Access Compliance Report Public Rights-of-Way (Curb Ramps)

Main Street: BOSTONIAN_DR Cross Street: MONTECITO_RD Location: NW

ADA ID: RPRK211215133621 Ramp Type: Type 4 - Parallel Initial Pass/Fail: Fail Overall Compliance: No Severity Score: 2

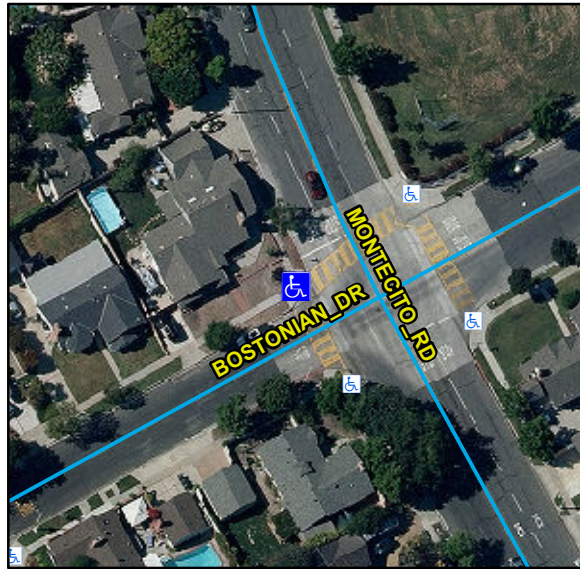
Compliance	Description	Data	Compliance	Description	Data
N/A	Ramp Length LT (in)	130	N/A	Ramp Length RT (in)	112
Yes	Ramp Width LT (in)	84	Yes	Ramp Width RT (in)	74
Yes	Ramp Run Slope LT (%)	7.8	Yes	Ramp Run Slope RT (%)	5.5
Yes	Ramp Cross Slope LT (%)	0.8	No	Ramp Cross Slope RT (%)	2.4
N/A	Landing Present	N/A	N/A	DWS Provided	N/A
N/A	Landing Length (in)	N/A	N/A	DWS Contrast	N/A
N/A	Landing Width (in)	N/A	N/A	DWS Length (in)	N/A
N/A	Landing Run Slope (%)	N/A	N/A	DWS Full Width	N/A
N/A	Landing Cross Slope (%)	N/A		DWS Offset Type	N/A
N/A	Landing Movement Obstructed?	N/A	N/A	DWS Offset Left (in)	N/A
	Landing Movement Type	N/A	N/A	DWS Offset Right (in)	N/A
N/A	Landing Shared	N/A			
N/A	Clear Space	Yes			
N/A	Clear Space To Crosswalk (in)	48			
N/A	Marked Crosswalk 1	Yes	N/A	Marked Crosswalk 2	Yes
	Crossing 1 Direction	SE		Crossing 2 Direction	NE
	Marked Crosswalk 1 Width (in)	144		Marked Crosswalk 2 Width (in)	144

Remove & Replace Curb Ramp With Two New Directional Ramps or Equivalent.

R304.5.3, STD 1115
